UNITED STATES PATENT AND TRADEMARK OFFICE

10/802,104

Office Action Summary

CRIST, ROBERT J.

ATTACHMENT

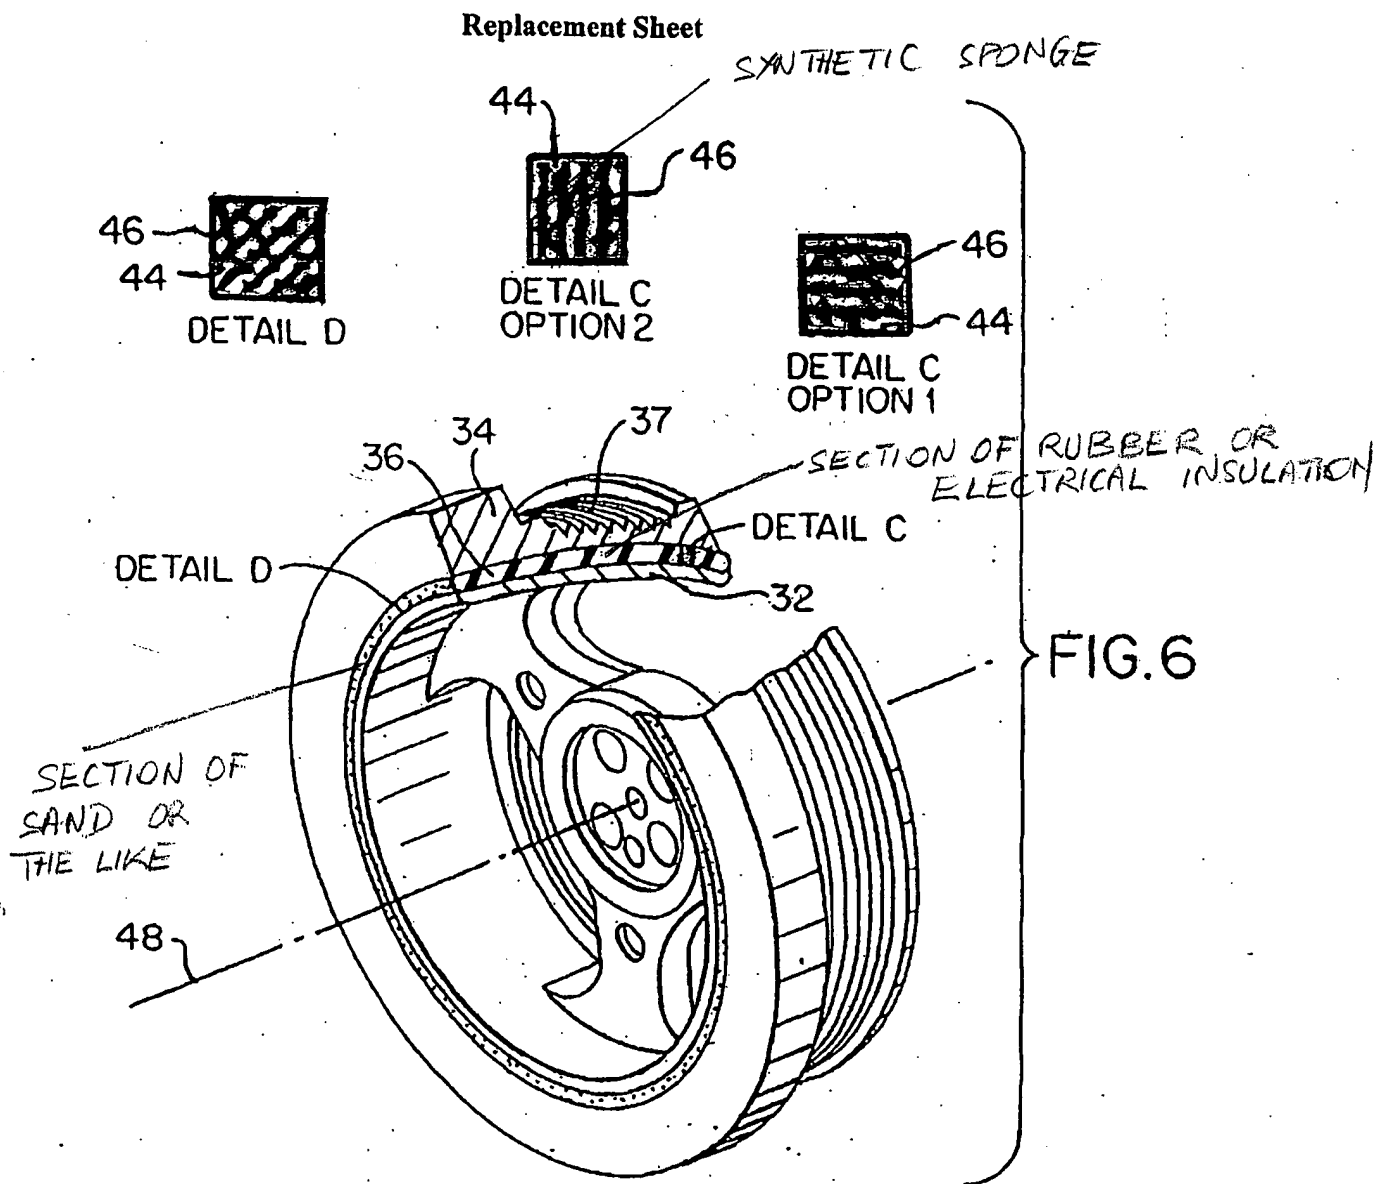
4. The drawings were received on January 8, 2007. These drawings are not accepted by the Examiner because the drawings are not in compliance with 37 CFR 1.84. For example:

- (a) The view number "FIG. 6" must not be used in association with a bracket. See 37 CFR 1.84(u)(2);
 - (b) When a portion of a view is enlarged for magnification purposes, the view and the enlarged view must each be labeled as separate views. 37 CFR 1.84(h)(2). However, Applicant did not label the detailed figures C or D separately from "FIG. 6"; and/or

- (c) The drawing symbols in FIG. 6 are inconsistent with each other. In fact, based on the drawing symbols for draftsman in MPEP 608.02, the same elastic element 36 is made of sand or the like, rubber or electrical insulation, and synthetic sponge as seen in Attachment.

5. The *original* drawings are objected to because the drawings do not comply with 37 CFR 1.84. For example:
 - (a) The sectional line, such as, S-S in FIG. 2 should have been changed to line 3-3 in order to correspond to FIG. 3. See 37 CFR 1.84(h)(3); and

- (b) The drawings are inconsistent with the specification and the claims. The

specification describes and claims 2-7 claim the fibers 46, however, the detailed figures C and D in FIGS. 6 show that the elements 46 are refractory material, not fibers in accordance with the drawing symbols for draftsperson in MPEP 608.02.

Corrected drawing sheets in compliance with 37 CFR 1.121(d) are required in reply to the Office action to avoid abandonment of the application. Any amended replacement-drawing sheet should include all of the figures appearing on the immediate prior version of the sheet, even if only one figure is being amended. The figure or figure number of an amended drawing should not be labeled as "amended." If a drawing figure is to be canceled, the appropriate figure must be removed from the replacement sheet, and where necessary, the remaining figures must be renumbered and appropriate changes made to the brief description of the several views of the drawings for consistency. Additional replacement sheets may be necessary to show the renumbering of the remaining figures. Each drawing sheet submitted after the filing date of an application must be labeled in the top margin as either "Replacement Sheet" or "New Sheet" pursuant to 37 CFR 1.121(d). If the changes are not accepted by the examiner, the applicant will be notified and informed of any required corrective action in the next Office action. The objection to the drawings will not be held in abeyance.

6. New corrected drawings in compliance with 37 CFR 1.121(d) are required in this application because of the objections above. Applicant is advised to employ the services of a competent patent draftsperson outside the Office, as the U.S. Patent and Trademark Office no longer prepares new drawings. The corrected drawings are required in reply to the Office action to avoid abandonment of the application. The requirement for corrected drawings will not be held in abeyance.
